Village of Grantsburg

Village Board Meeting Agenda Monday, February 9, 2026 at 4:00 p.m. Village Board Room, 316 S. Brad Street

RE: Change Order 01
Village of Grantsburg
Grantsburg WWTP Improvements
SEH No. 184139 71.50

Change Order No. 1 to the Grantsburg WWTP Improvements project is enclosed. This Change Order includes six (6) items previously approved as individual line items by the Village Board and two (2) items that have not been approved. SEH recommends approval of Change Order No. 1 to incorporate the following changes into the Contract with Market & Johnson, Inc. (Contractor):

Save: 9/2/2025 3:19 PM mappal Plot: 9/2/2025 3:27 PM
X:\P\GRANT172213\Drawings\10-Civil\cd\dwg\sheet\GRT172213_WPP.dwg

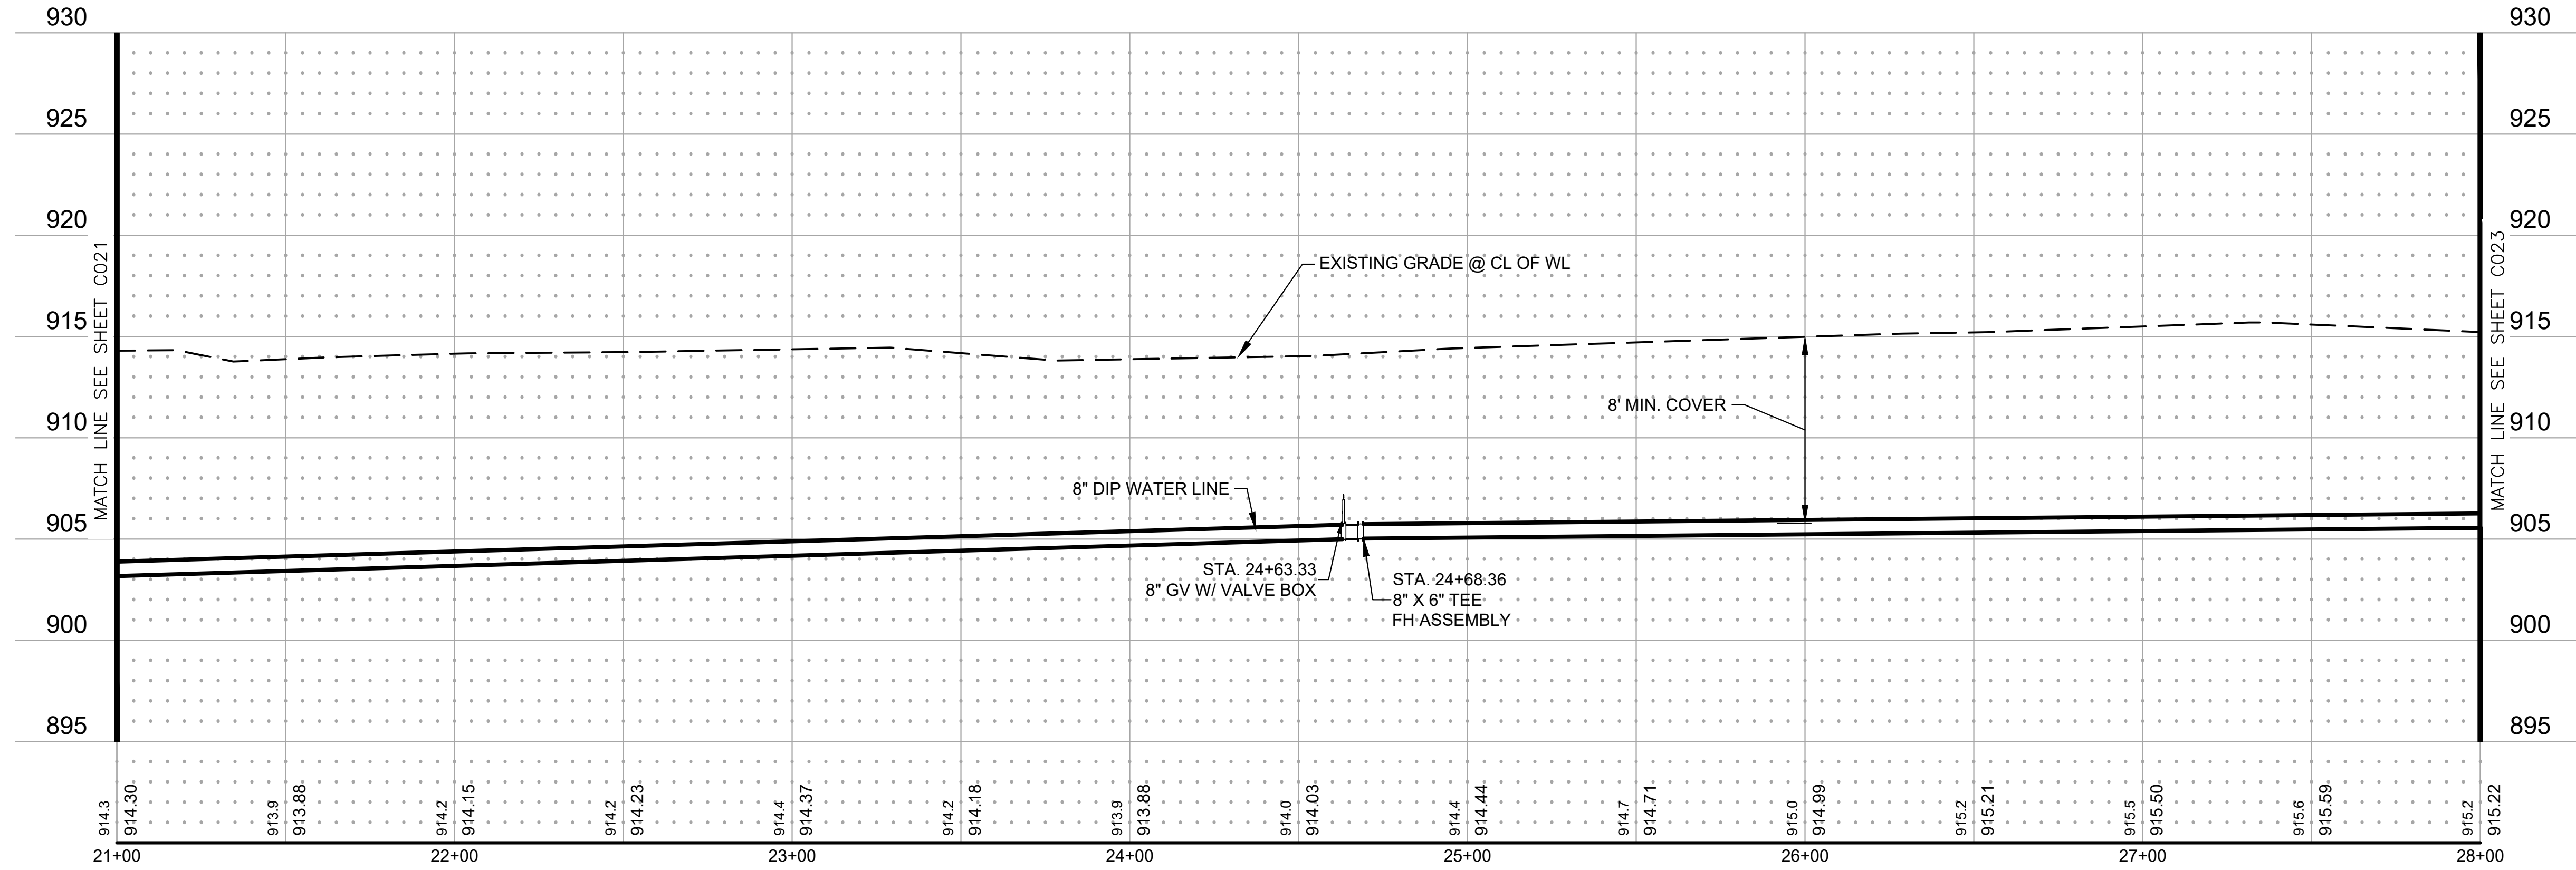
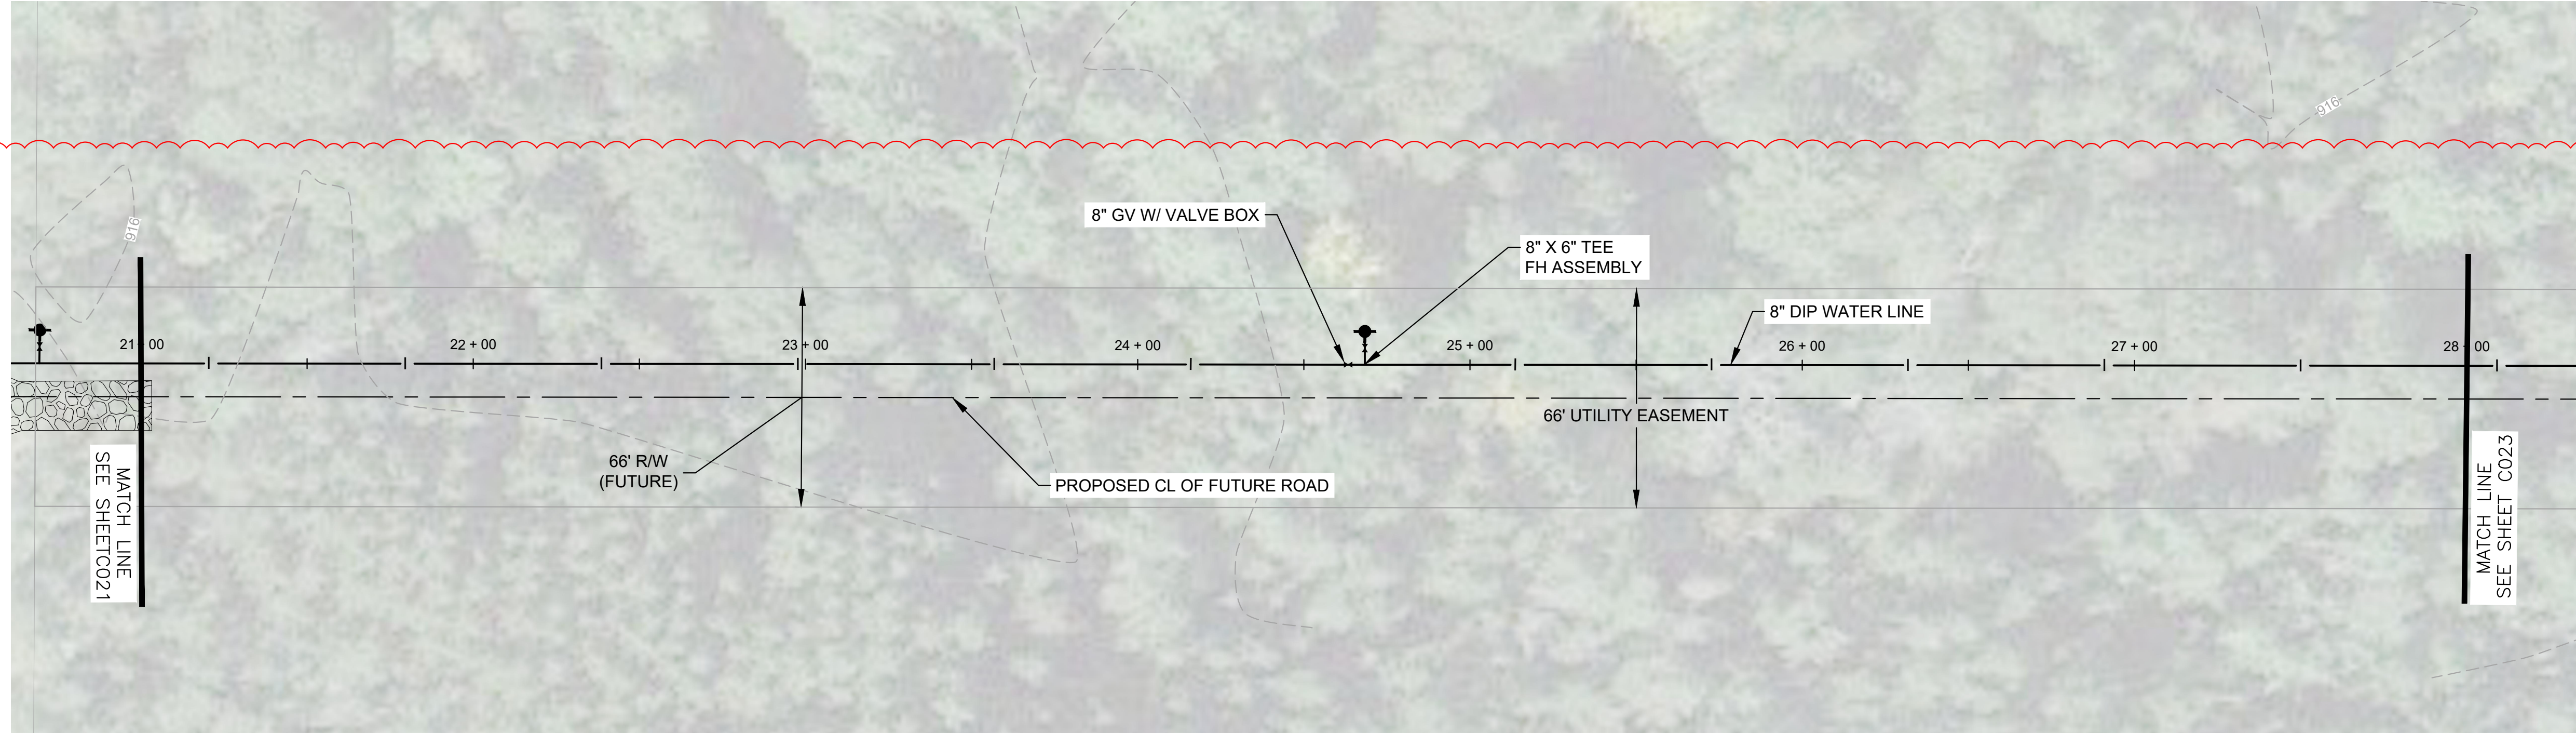
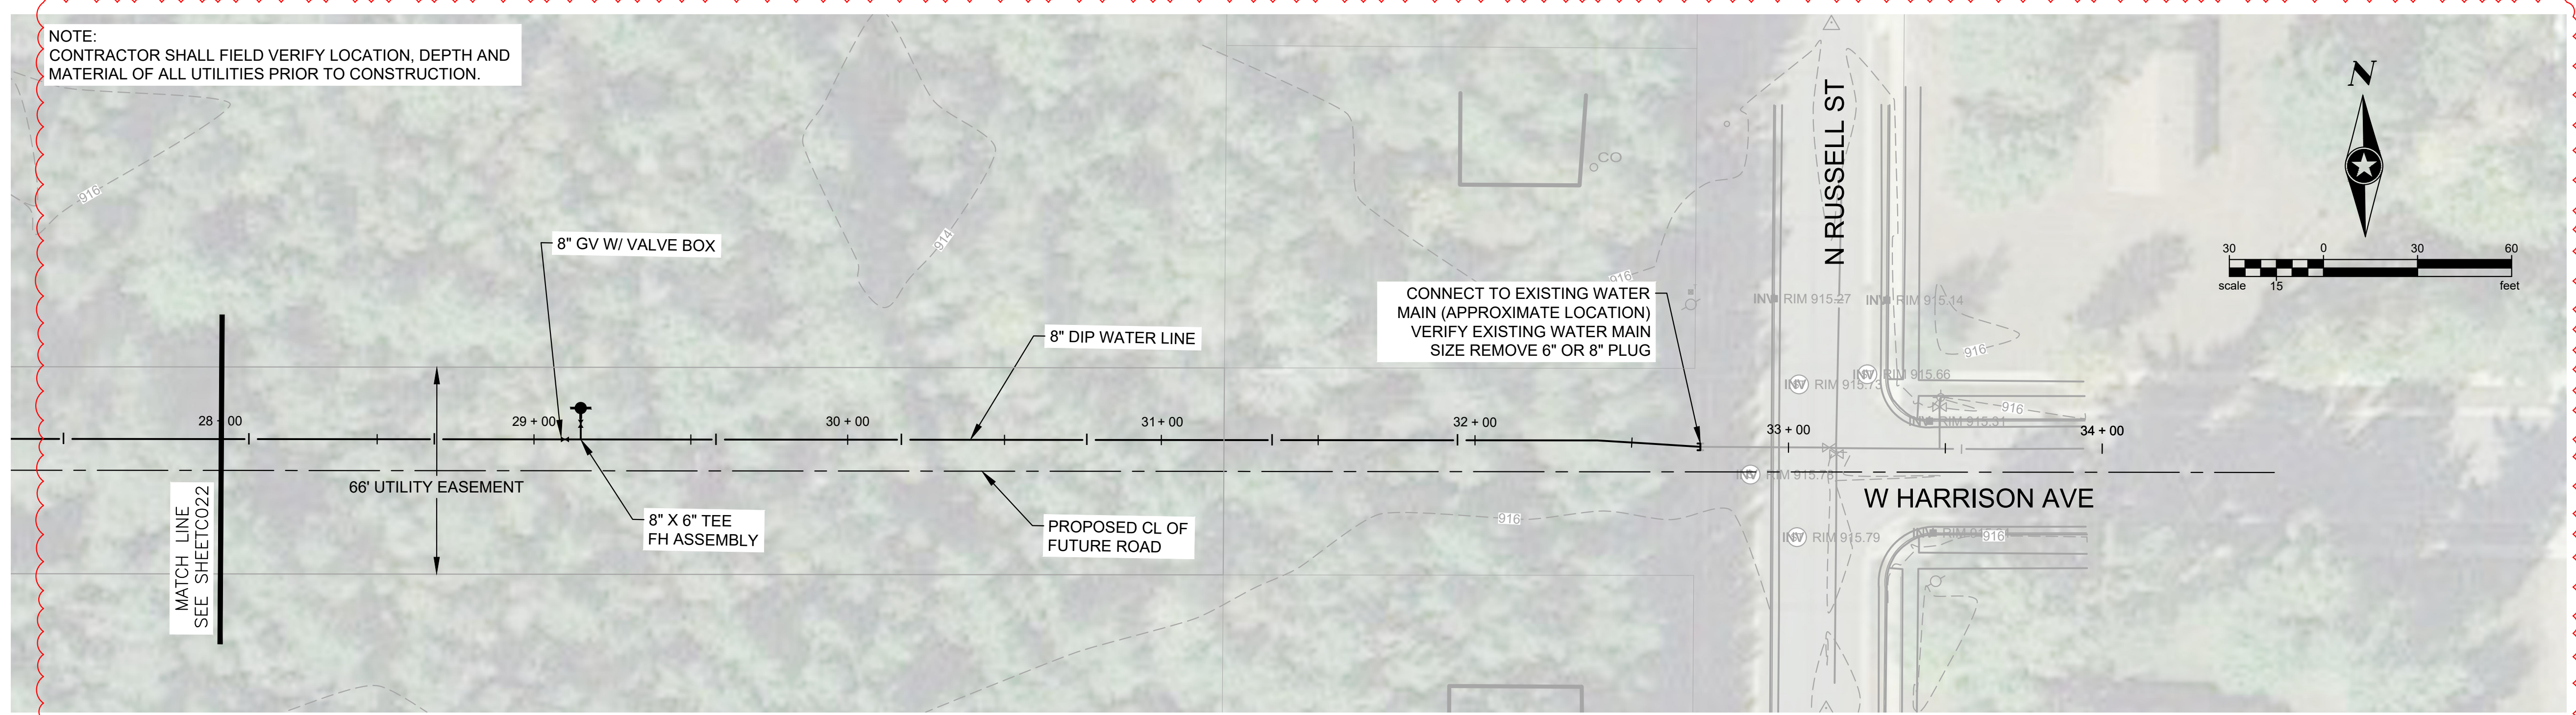
- **Change Order Request #02 – Watermain Alignment Revision (WCD #1)**
The alignment adjustment results in no cost impact and no change to Contract Time; COR #02 is recommended for approval. This change was approved by the Grantsburg Village Board on December 8, 2025.

10 - LIFT STATION SITE PLAN

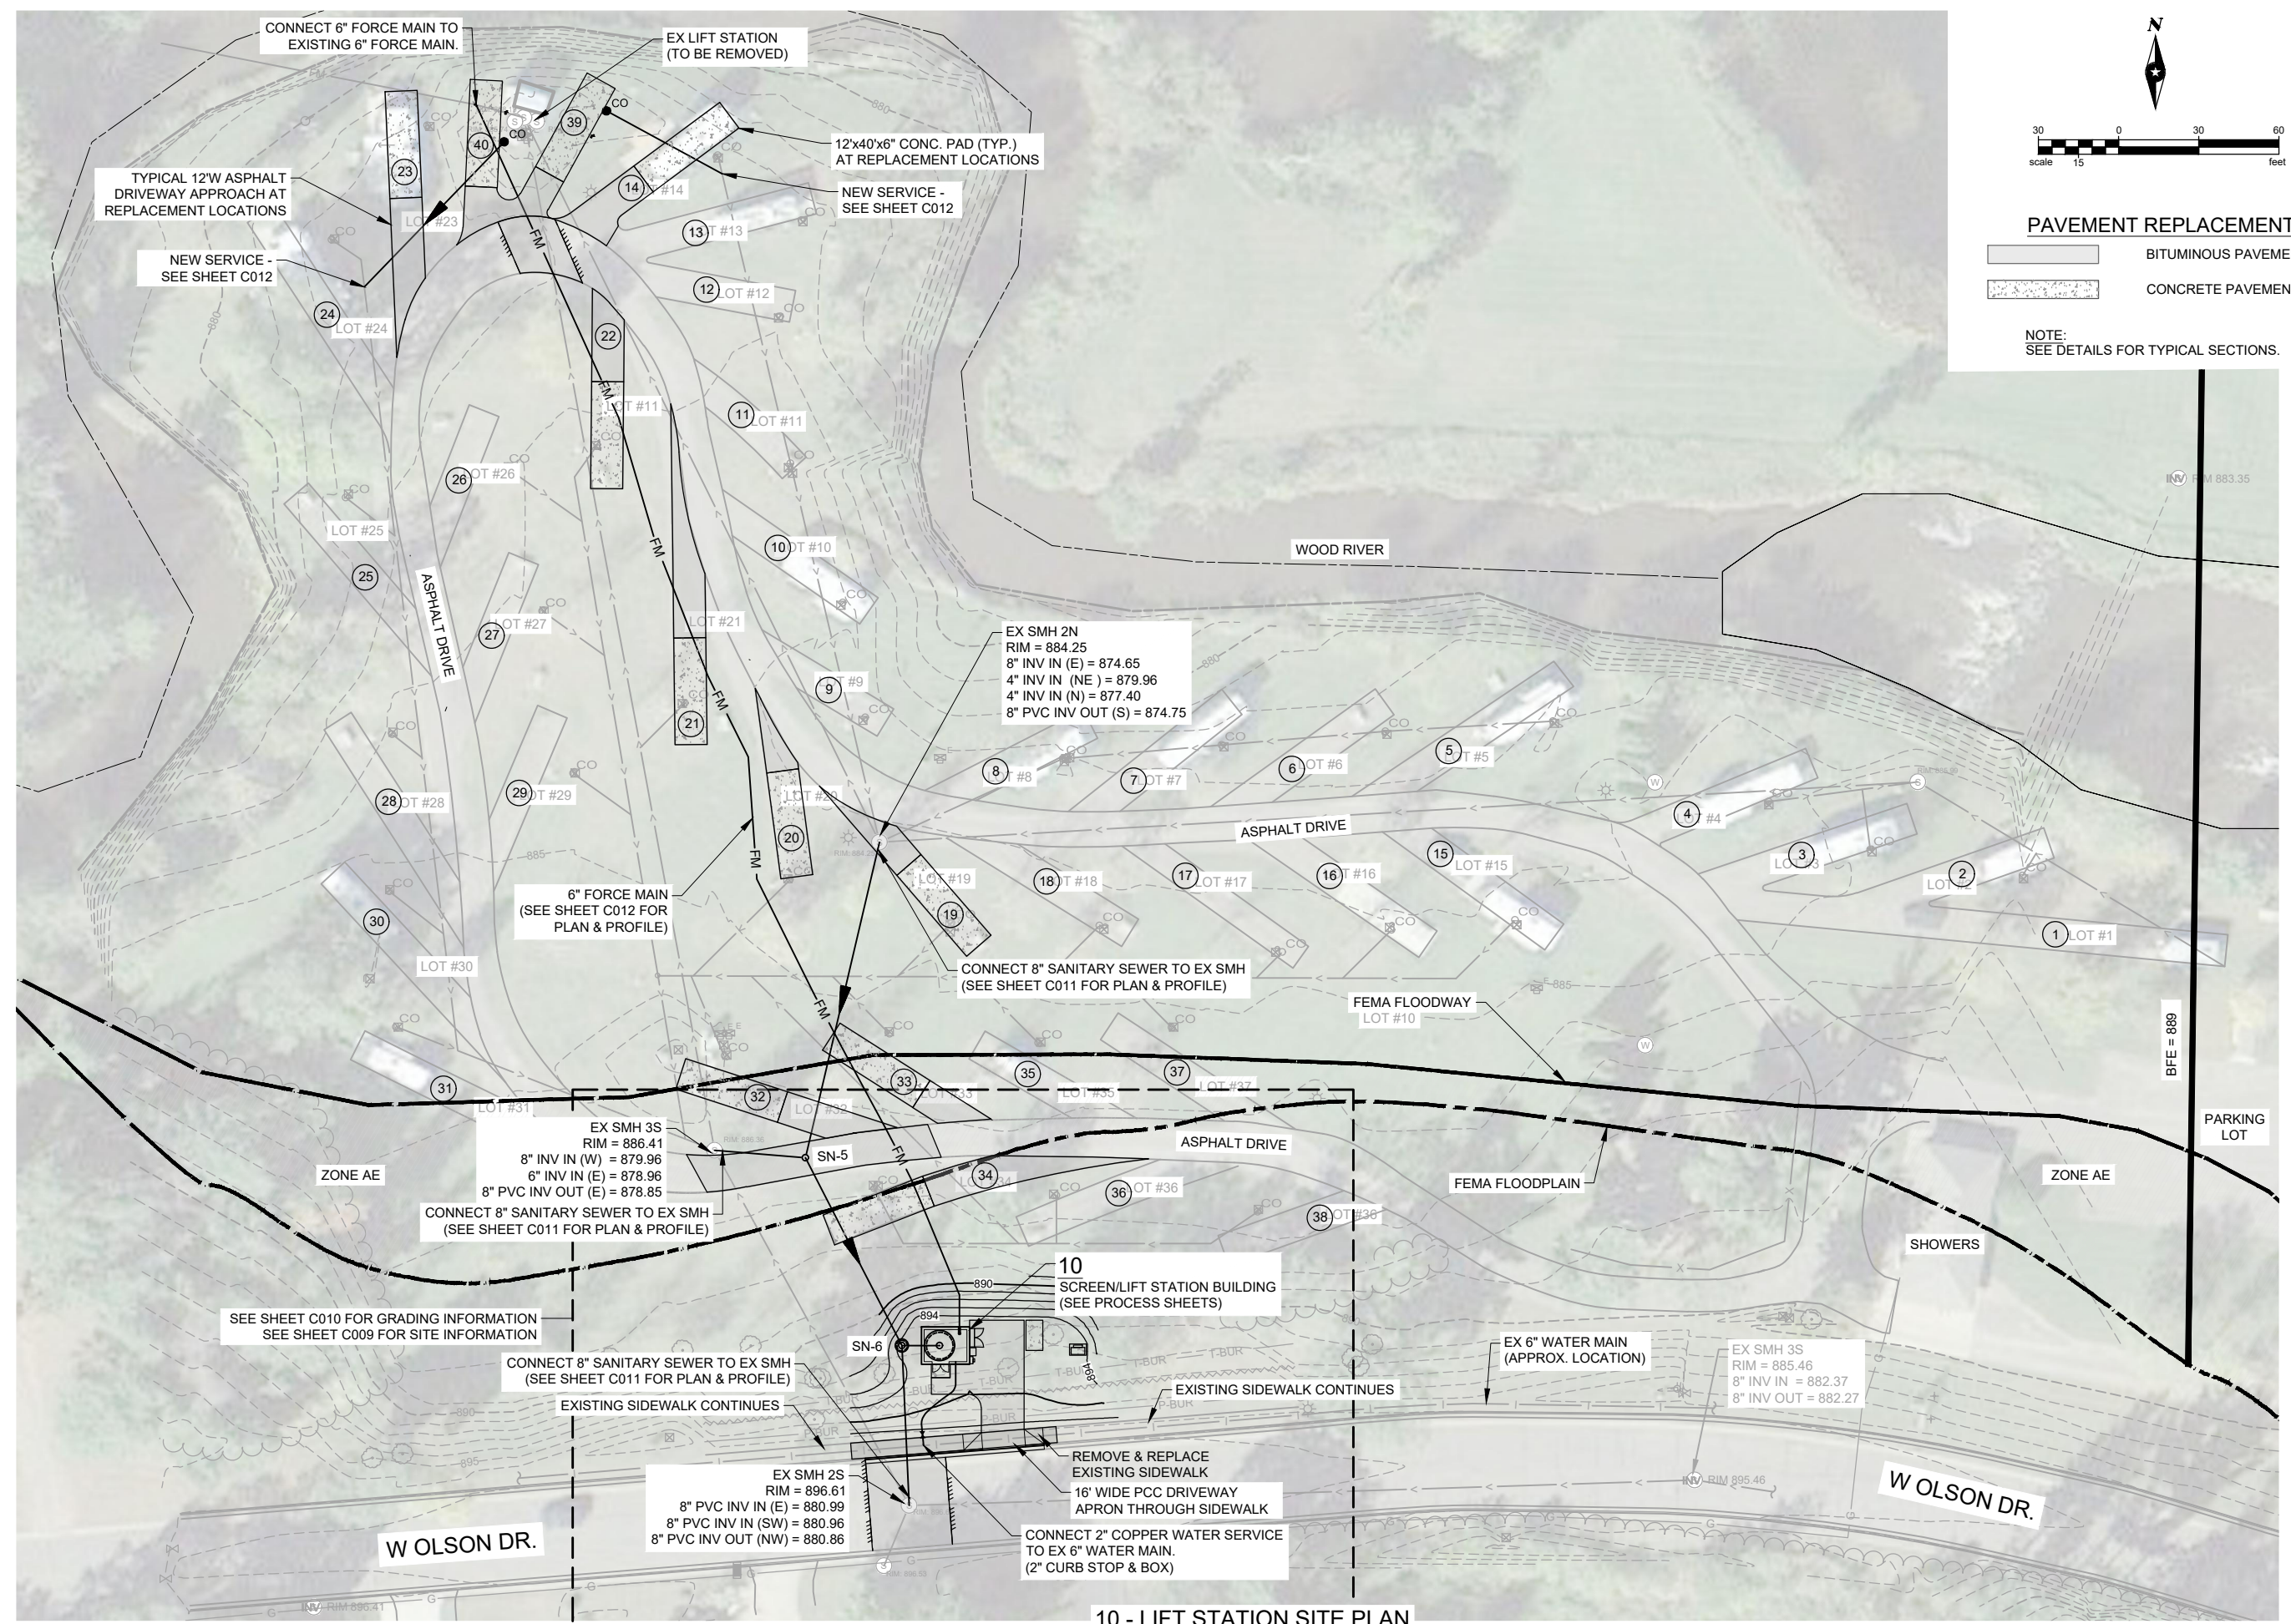
- **Change Order Request #04R2 – Lift Station Relocation**
This revision accounts for relocation of the new Main Lift Station approximately 10 feet west of the originally proposed location to avoid conflicts with an unmarked 8-inch water main and to accommodate work that was not originally shown on the Drawings. The change includes additional tree removal that was required for installation of the lift station but not shown on the Drawings, repair to a new sidewalk which was constructed after site survey was conducted and therefore not on the Drawings, and additional excavation/backfill for the building relocation. The change amount of \$12,492.00 is recommended for approval, with no change to Contract Time
